REVISIONS					DESCRIPTION
REV	DATE	BY	APP'D	MR	
1	10-25-23	CH	MR		RECORD DRAWINGS

RECORD DRAWINGS
THESE RECORD DOCUMENTS HAVE BEEN PREPARED USING INFORMATION BY OTHERS. ANCHOR QEA, LLC HAS NOT VERIFIED THE ACCURACY OR COMPLETENESS OF THIS INFORMATION IN ITS ENTIRETY AND SHALL NOT BE RESPONSIBLE FOR ANY ERRORS OR OMISSIONS WHICH MAY BE INCORPORATED HEREIN AS A RESULT.

MEADOWDALE BEACH PARK
AND ESTUARY DESIGN
19-103913LDA

PORTABLE TOILET ENCLOSURE ELEVATIONS

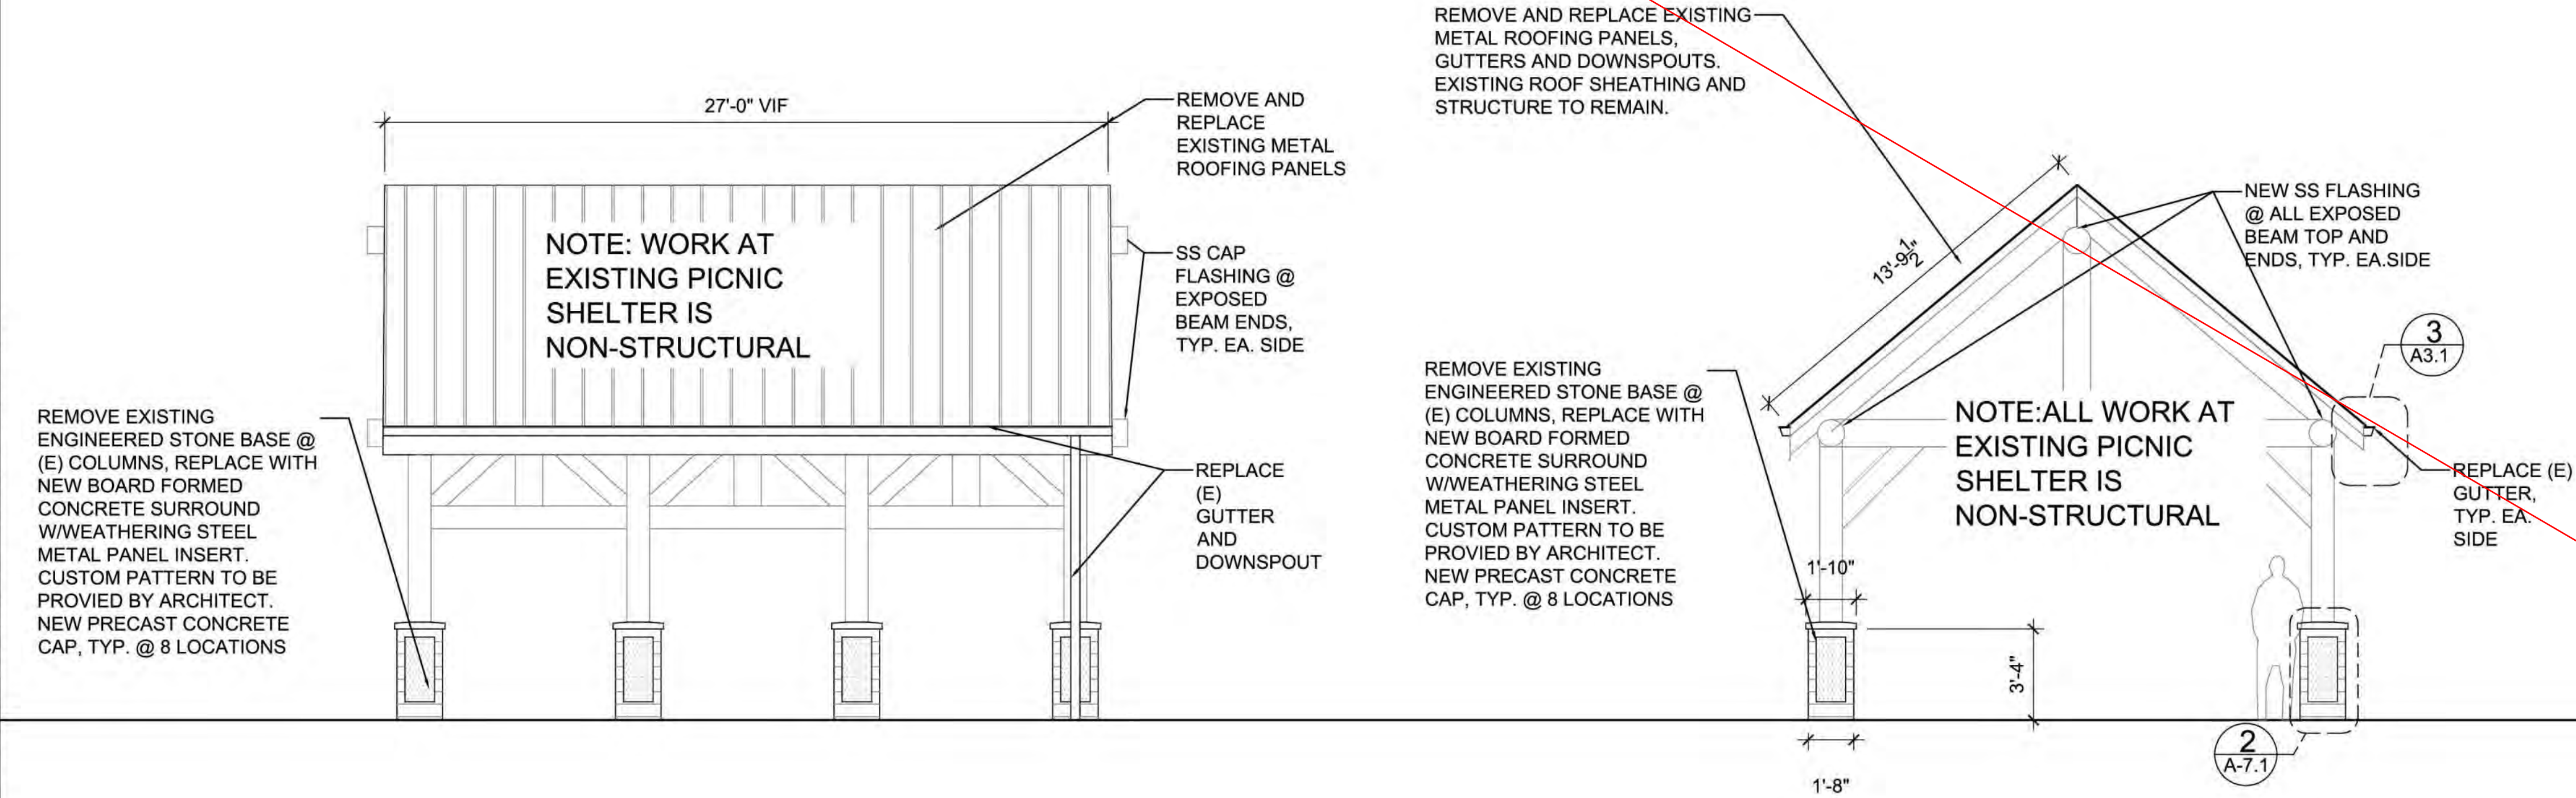
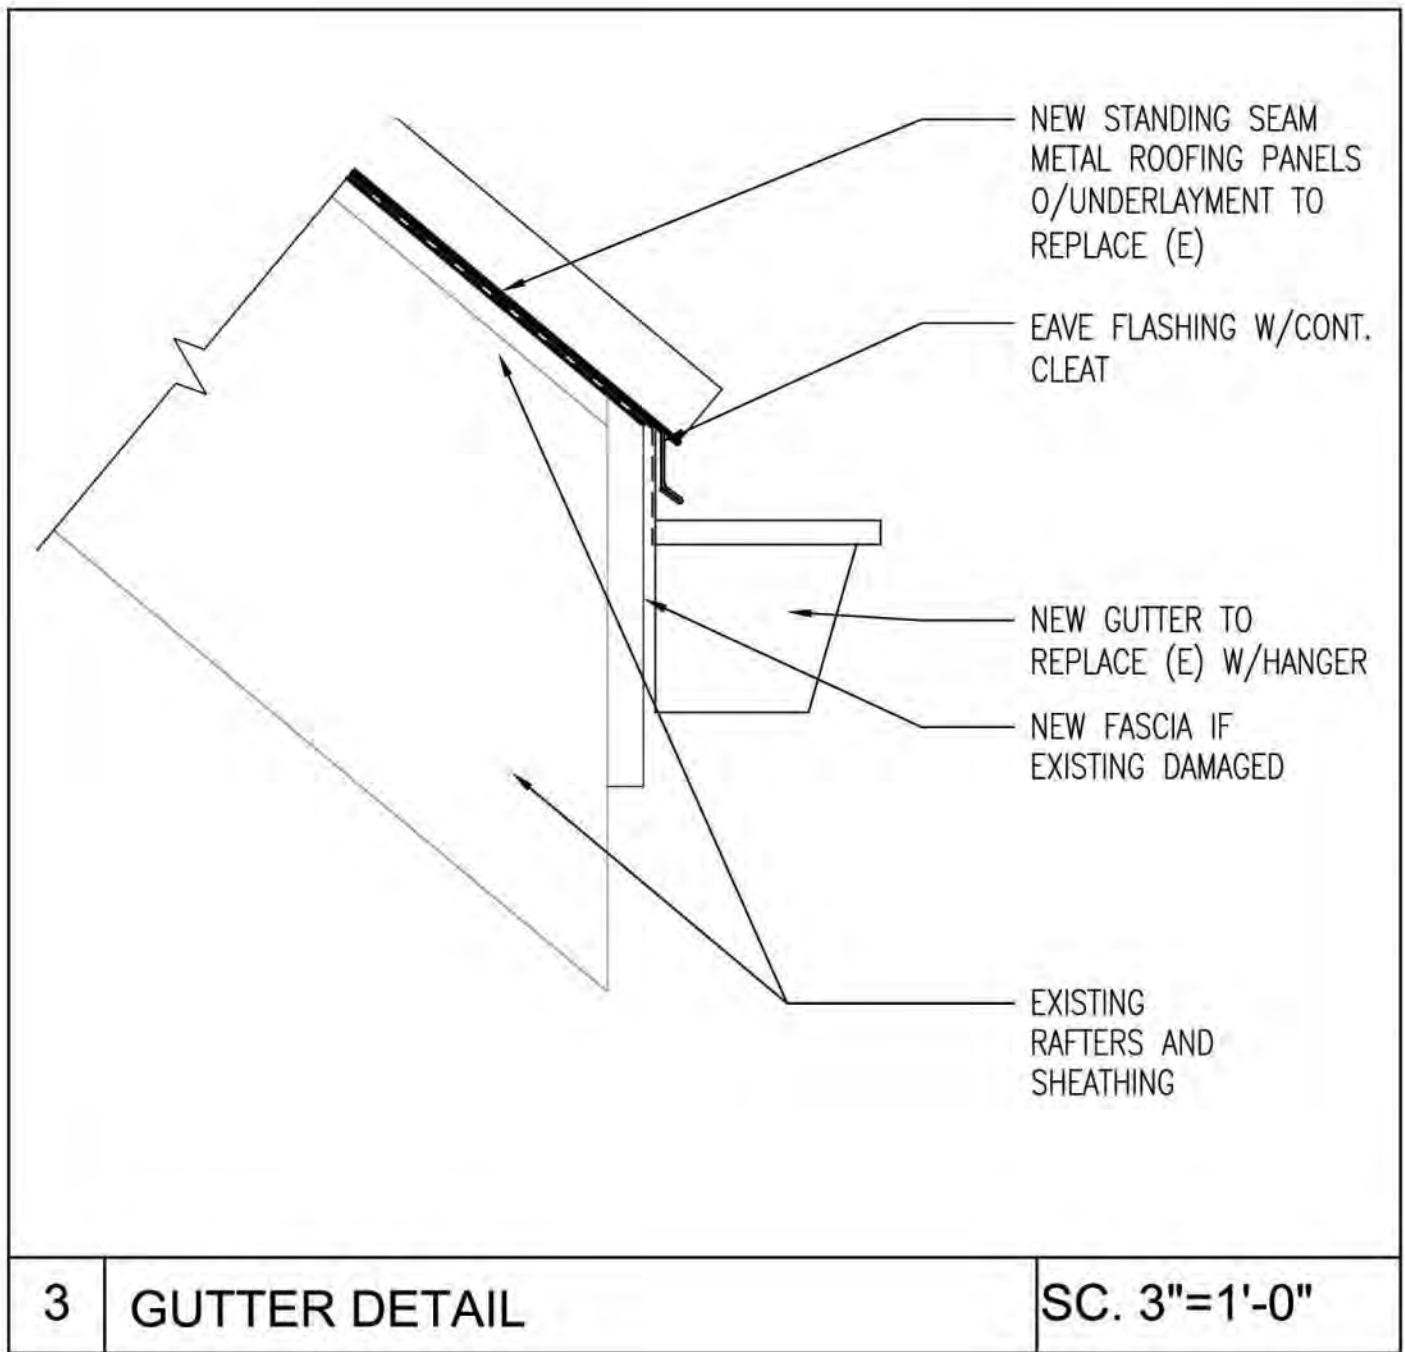
PICNIC SHELTER
DEMOLISHED, DUE TO ROT.
NEW SHELTER DESIGNED
AND RELOCATED, PER
CHANGE ORDER
